Old Connaught Phase A1 LRD Quality Audit

0126446DG0023

**Old Connaught Phase
A1 LRD: Road Safety
Audit Stage 1**

012644DG0022

Figure 2-2 – Residence Access in Western Homezone

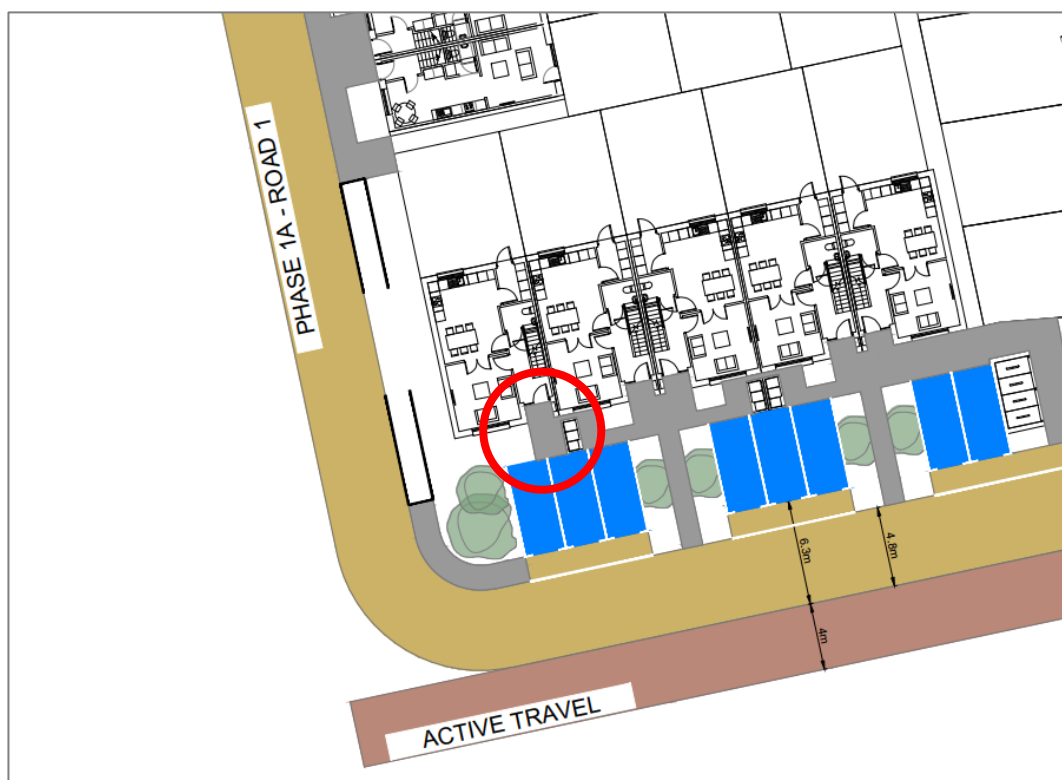
It is unclear how the homeowner in the residence circled below would be able to reach the shared road or pedestrian facility. Access to the shared road is restricted when turning left when exiting the dwelling and turning right when exiting the dwelling necessitates traversing over grassed area to get to the shared road. This might be restrictive to users with wheelchairs or buggies.

The design team should provide sufficient access to the shared road and pedestrian facility from the homeowner's front door.

2.2	Yes	Yes		-
2.3	Yes	Yes	An uncontrolled crossing to the east of the junction will be provided during the detailed design stage.	-
3.3.2.1	Yes	Yes	To be updated during detailed design stage by landscape architect.	-

Figure 2-4 – Future Pedestrian Crossing Provisions

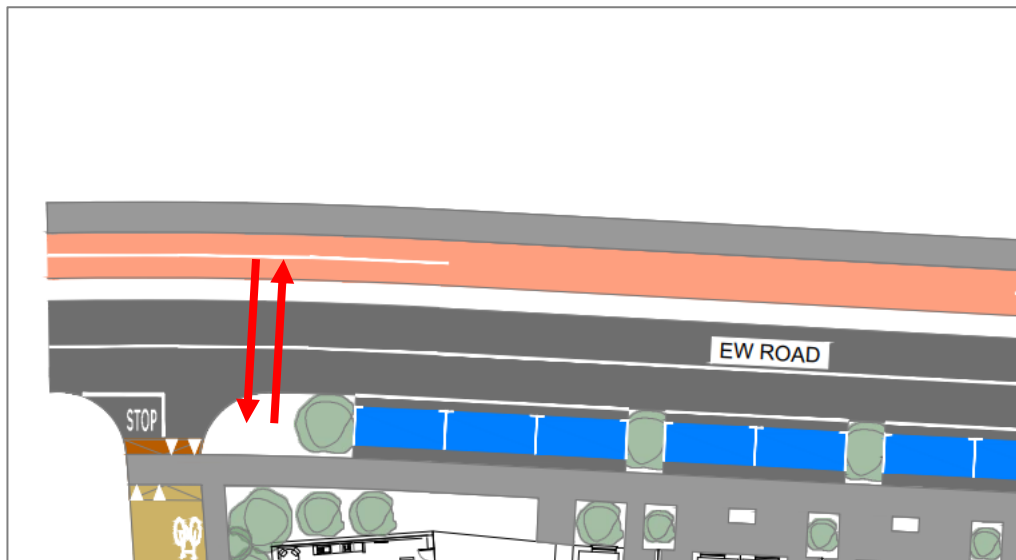
There may be a future need for pedestrians to cross EW Road. The design does not allow for future implementation of pedestrian crossings along EW Road.

The design team should consider future pedestrian crossing provisions across EW Road.

Figure 2-1 – Sight Lines at Entrance

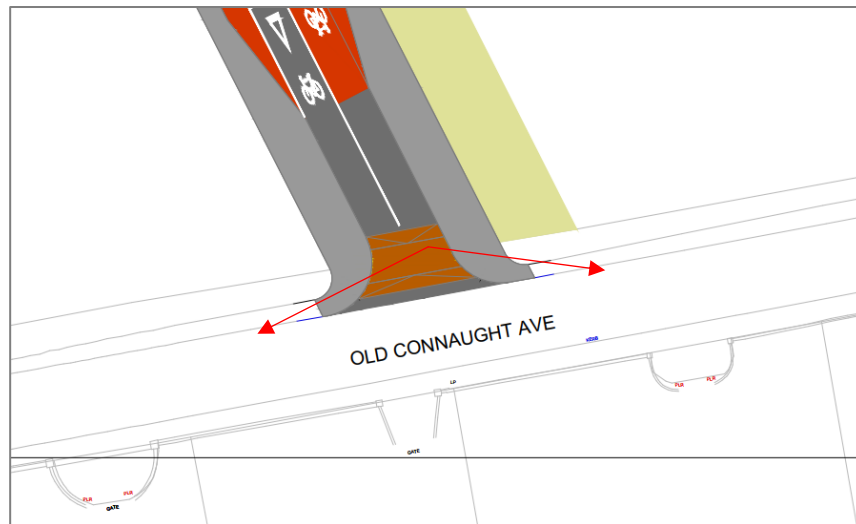
It is unclear if there are sufficient sight lines to the left and right of the entrance to the development along Old Connaught Avenue. Restricted visibility splays at the development entrance could result in vehicle collisions due to insufficient visibility provisions for motorists entering and exiting the development junction.

The designer should provide visibility splays to Standard at the development entrance junction.

2.1	Yes	Yes		-
2.2	Yes	No	A 24 m stacking length has been provided within the current design to accommodate anticipated vehicle demand while reducing the length of shared carriageway used by both cyclists and vehicles. This arrangement is proposed as an interim measure and will be superseded by a signal-controlled junction incorporating dedicated cycling facilities as part of the ultimate scheme.	Yes

Figure 2-2 – Vehicle Stacking Length at Entrance

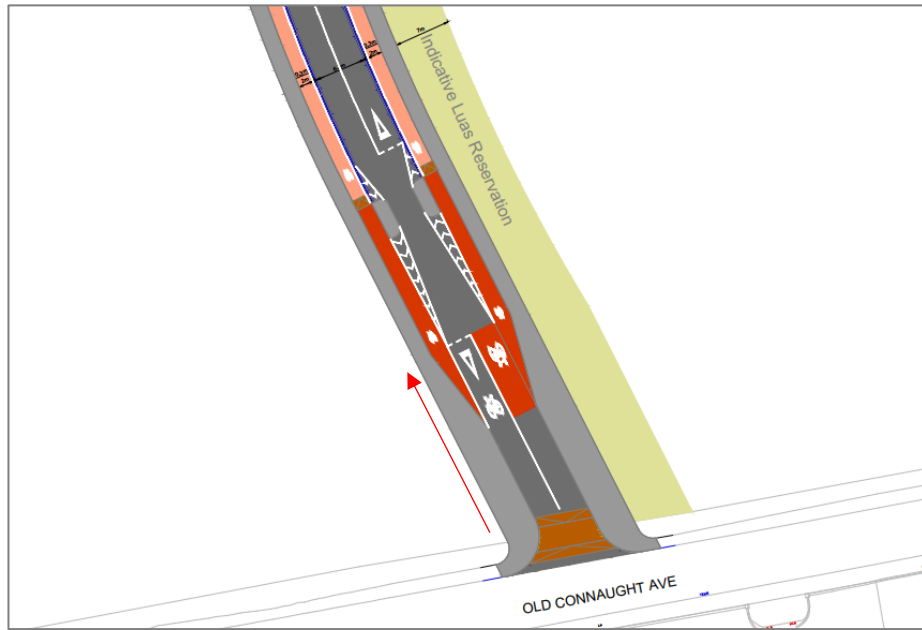
It is unclear if sufficient stacking distance is provided for vehicles entering the development ahead of the yield markings at the entrance to the development. If the traffic volumes entering the development is high, it might result in vehicles stacking into Old Connaught Avenue, resulting in potential rear-end collisions as a result of vehicles, particularly where there may be visibility issues.

The designer should ensure that a sufficient stacking length is provided ahead of the yield sign for vehicles entering the development.

Figure 2-3 – Vehicle Queue Length at Entrance

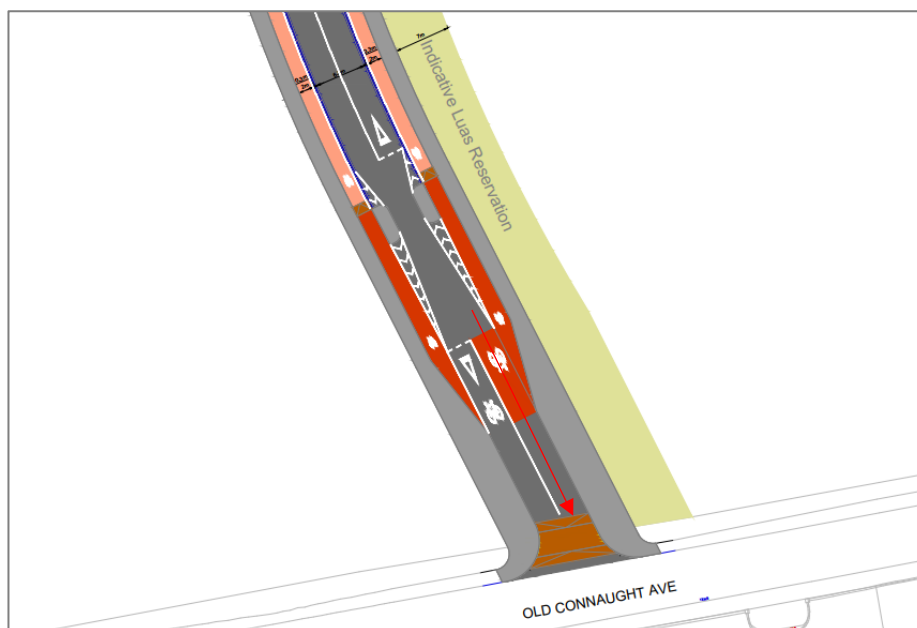
It is unclear if sufficient queueing distance is provided for vehicles exiting the development onto Old Connaught Avenue. If the traffic volumes exiting the development is high, it might result in vehicles stacking into the pinch point along NS Road, resulting in potential vehicle conflict.

The designer should ensure that a sufficient queueing length is provided ahead of the Old Connaught Avenue junction for vehicles exiting the development.

2.3	Yes	No	A 24 m queue length has been provided within the current design to accommodate anticipated vehicle demand while reducing the length of shared carriageway used by both cyclists and vehicles. This arrangement is proposed as an interim measure and will be superseded by a signal-controlled junction incorporating dedicated cycling facilities as part of the ultimate scheme.	Yes

Figure 2-4 – Large Corner Radii

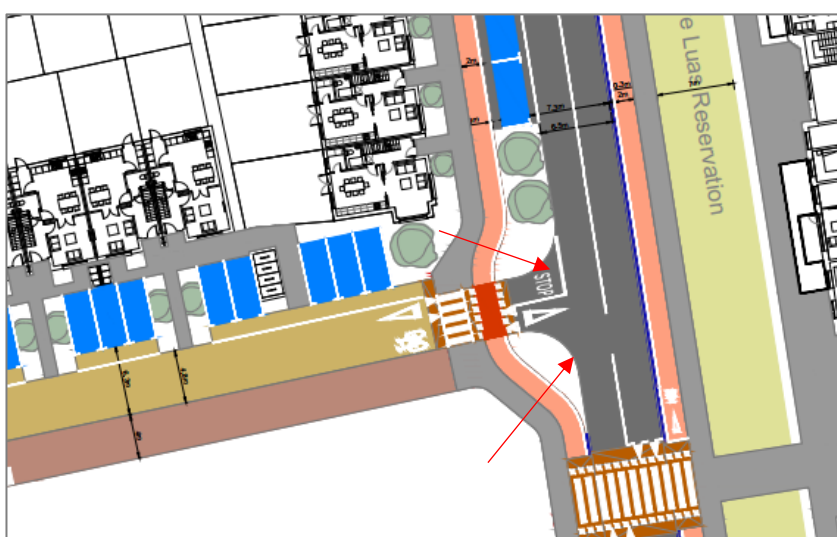
The corner radii at junctions within the development appear to be large, which might encourage higher entry/exit speeds along the development roads. This could result in conflict between motorists and pedestrians.

The designer should ensure that the corner radii at junctions within the development are small enough to slow vehicles down for the safety of all users within the development.

2.4	Yes	No	The junctions have been designed with 4.5 m corner radii, which are in accordance with DMURS recommendations for local streets, to provide a low-speed environment while accommodating service, refuse and emergency vehicles.	Yes

Figure 2-7 – Example of lack of provisions for Visually Impaired Pedestrians

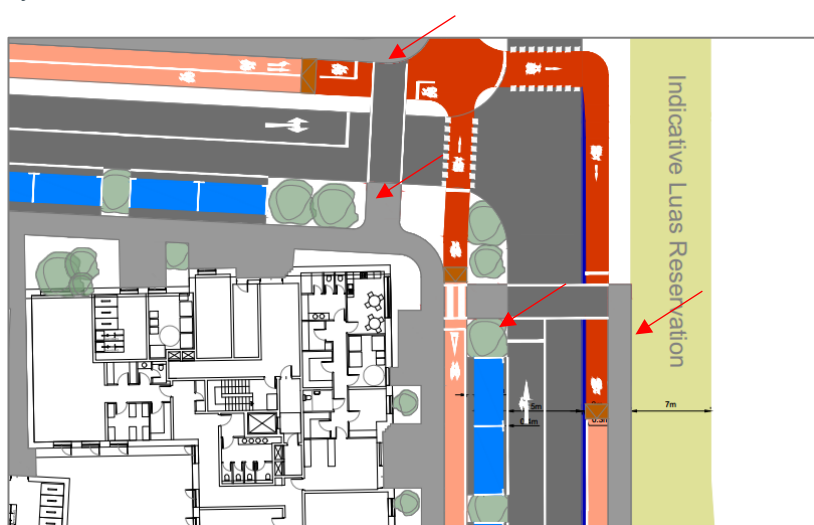
There are no tactile paving provisions on footpaths throughout the development, which could lead to confusion for visually impaired pedestrians along the scheme. This could result in pedestrians coming into conflict with cyclists and motorists.

The designer should provide tactile paving to standard, for visually impaired pedestrians.

2.7	Yes	Yes		-
2.8	Yes	Yes		-
2.9	Yes	No	Road markings will be revised to provide clearer guidance to cyclists and direct them into the appropriate lane arrangement.	Yes

Figure 2-8 – Abrupt End to Footpath

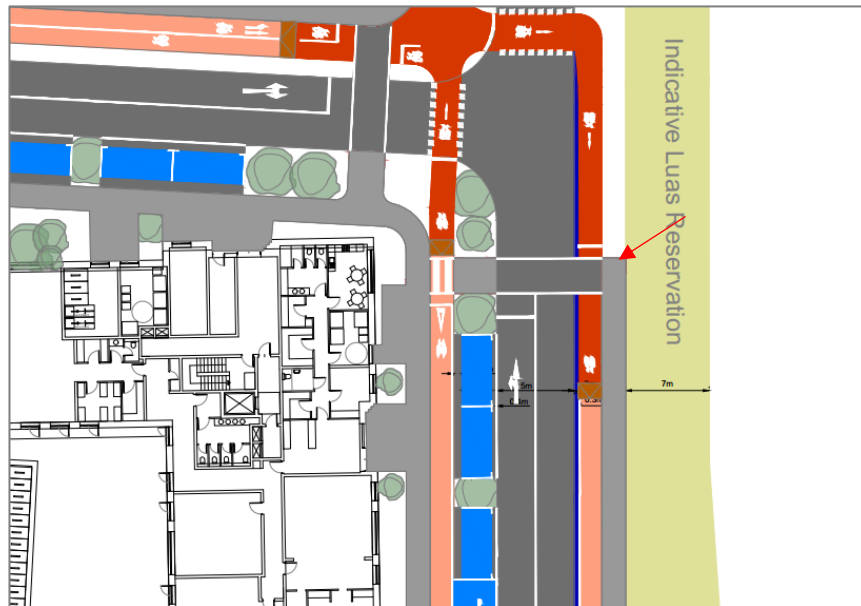
The eastern footpath at the northern end of NS Road ends abruptly with no indications for further pedestrian movement. This could result in pedestrian confusion, especially visually impaired users, resulting in potential conflict between pedestrians and cyclists/vehicles.

The designer should provide clear indications of the travel direction and provide adequate measures to assist visually impaired pedestrians in navigating the stopped end of the footpath.

Figure 2-9 – Cycle Path Alignment

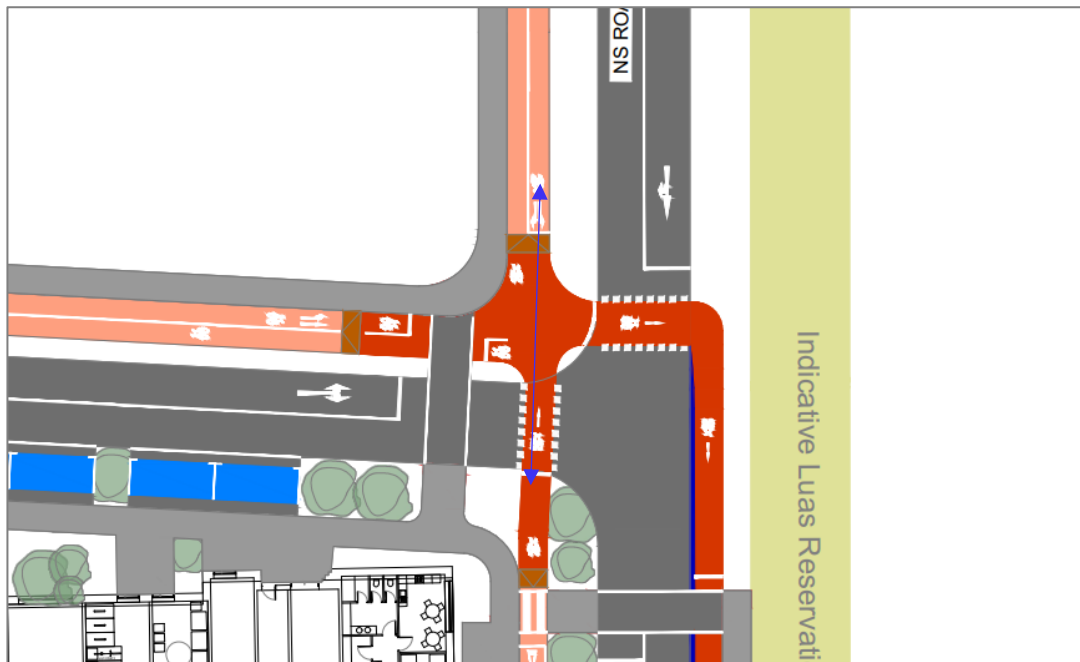
The northbound cycle path at the northern end of NS Road is aligned in a manner that could result in cyclists moving northward (after crossing EW road) coming into conflict with cyclists traveling southbound along the cycle path at the northern end of NS Road, and vice versa.

The designer should align the northern cycle path in a way which ensures that the northbound cycle path is aligned throughout (before and after crossing the junction).

Figure 2-11 – Road Markings for the NS Road / Old Connaught Avenue

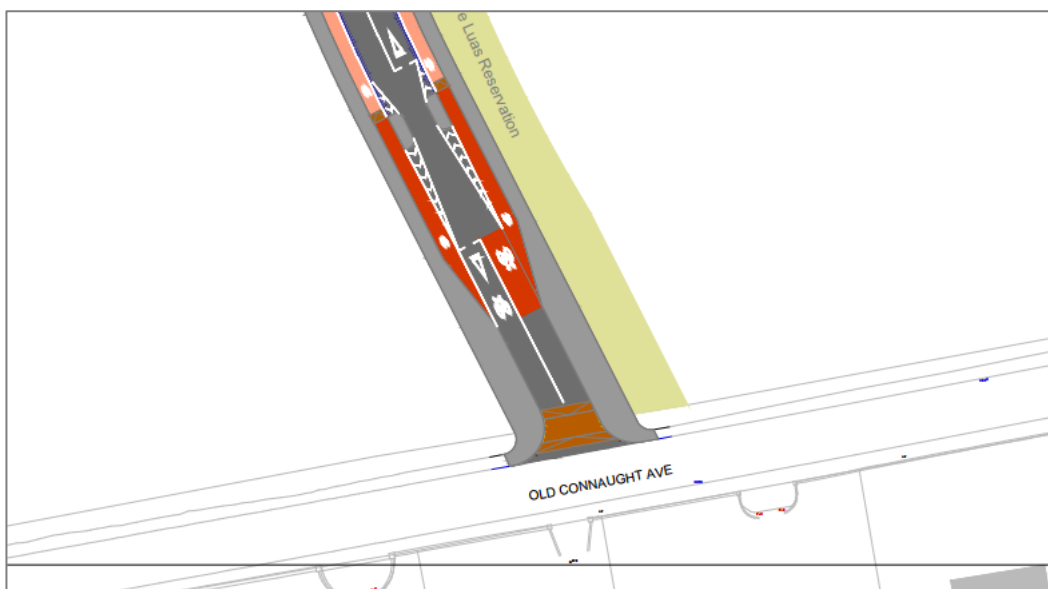
Road markings for the NS Road / Old Connaught Avenue are not indicated. This results in uncertainty about pedestrian/vehicular priority at the junction. There is no indication that vehicles should Stop for Old Connaught Avenue traffic, which could result in collisions.

The design team should ensure that road markings for the NS Road / Old Connaught Avenue are provided to indicate pedestrian/vehicular priority and that vehicles should Stop for Old Connaught Avenue traffic.

Figure 2-12 – Cyclist Access to Crossing

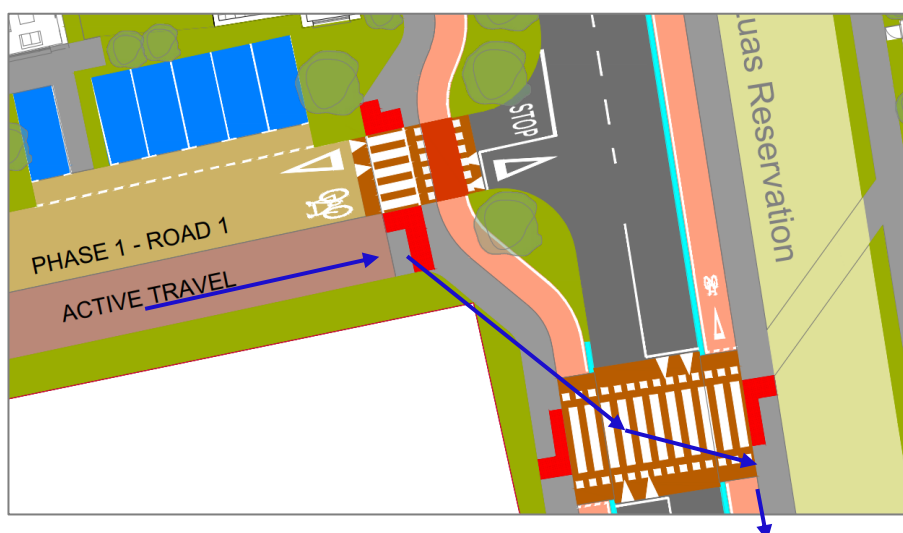
The current layout of the NS Link Street / Phase A1 Road 1 Southern Link junction requires cyclists traveling along the active travel area to traverse pedestrian and oncoming cyclist facilities in order to cross NS Link Street to access the southbound cycle lane along NS Link Street. Additionally, northbound cyclists wishing to turn left into or out of the active travel area have no provision. This could result in collisions between cyclists and pedestrians/other cyclists.

The design team should ensure that a suitable arrangement is provided to safely facilitate all movements.

Figure 2-13 – Visibility of Signal Heads at Crossings

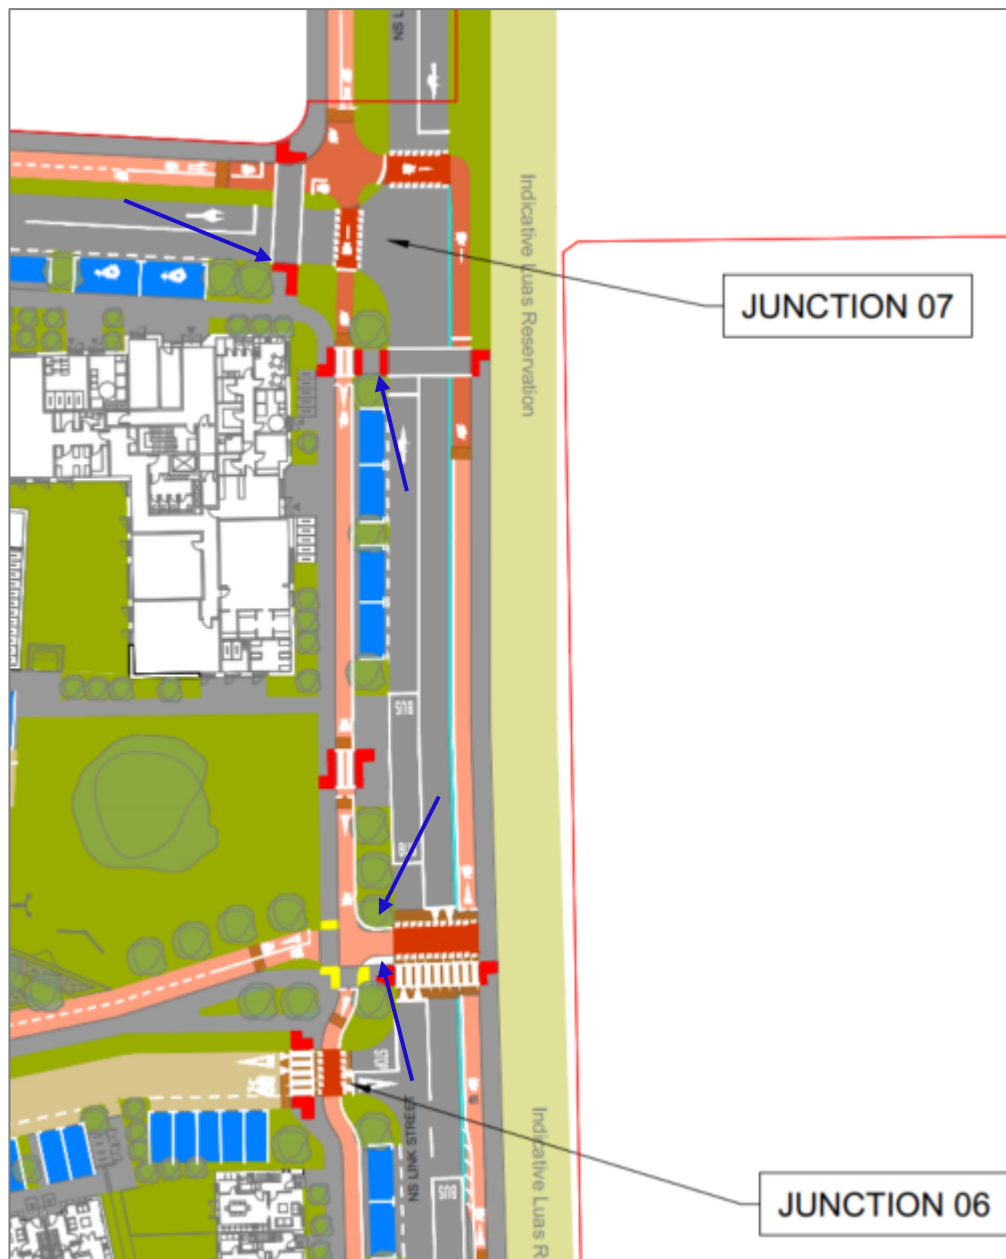
The current tree provisions at the EW Link Street / NS Link Street Crossing as well as the Phase A1 – Road A / NS Link Street Crossing could potentially restrict the visibility of motorists along EW Link Street and NS Link Street to observe the crossing signal heads at both crossings. This could result in motorist/pedestrian collisions.

The design team should ensure that visibility to signal heads is to standard for motorists approaching crossings.

2.14	Yes	Yes	During the detailed design stage, the proposed tree planting will be reviewed to ensure that adequate visibility is maintained. Trees of appropriate size will be selected or relocated/removed where necessary to achieve the required visibility standards.	-

Figure 2-15 – Trees Restricting Visibility Splays

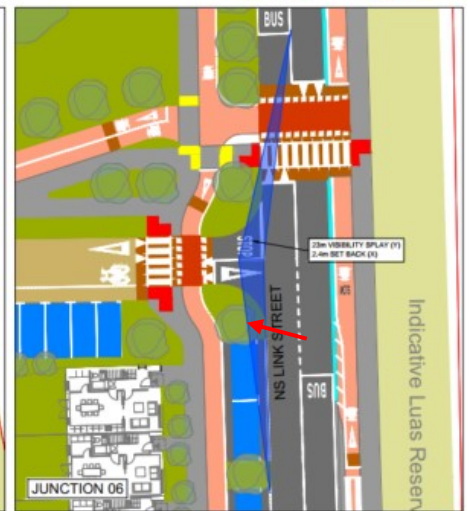
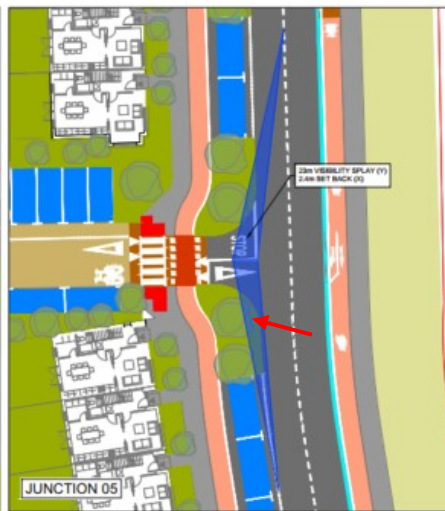
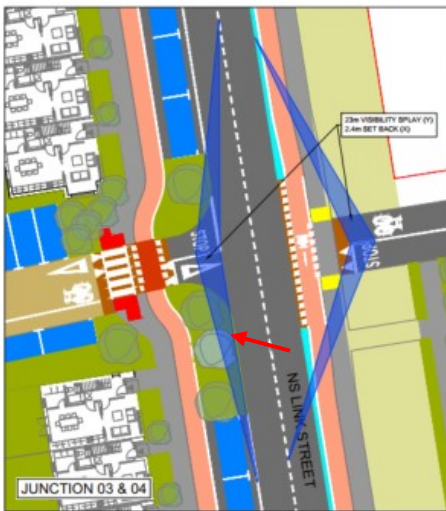
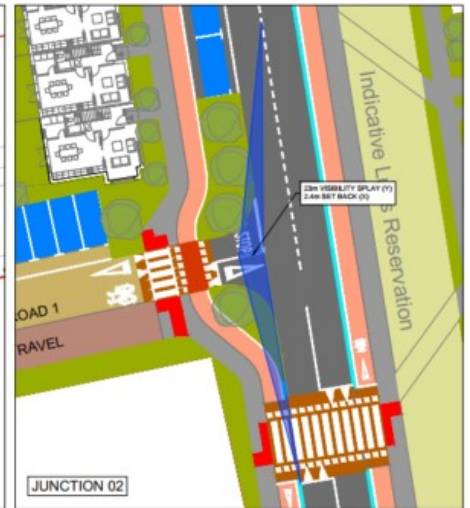
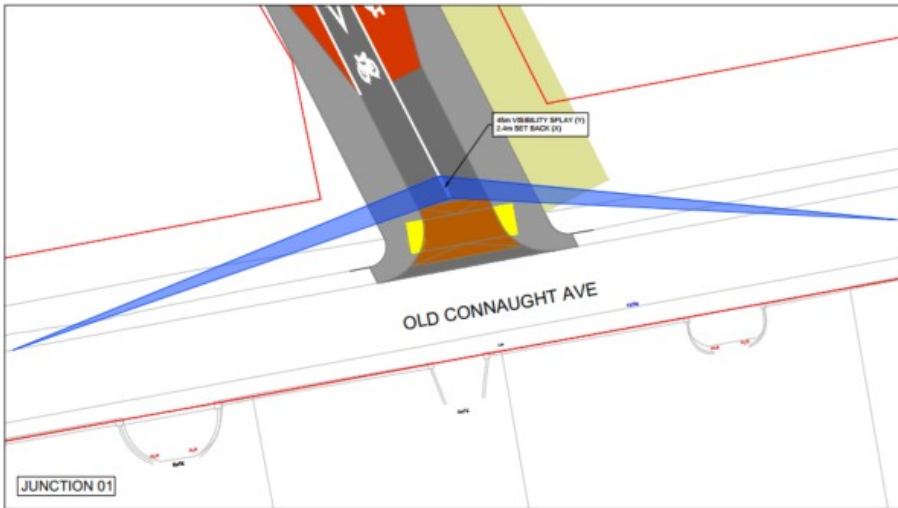
The current tree provisions at the junctions 3, 5, 6, 9, 10 and 11 restrict the y-distance visibility splays of motorists exiting the junctions. This could result in vehicle collisions.

The design team should ensure tree provisions do not restrict the visibility splays of vehicles within all junctions and that visibility splays at junctions throughout are to Standard.

2.16	Yes	Yes	During the detailed design stage, the proposed tree planting will be reviewed to ensure that adequate visibility is maintained. Trees of appropriate size will be selected or relocated/removed where necessary to achieve the required visibility standards.	-
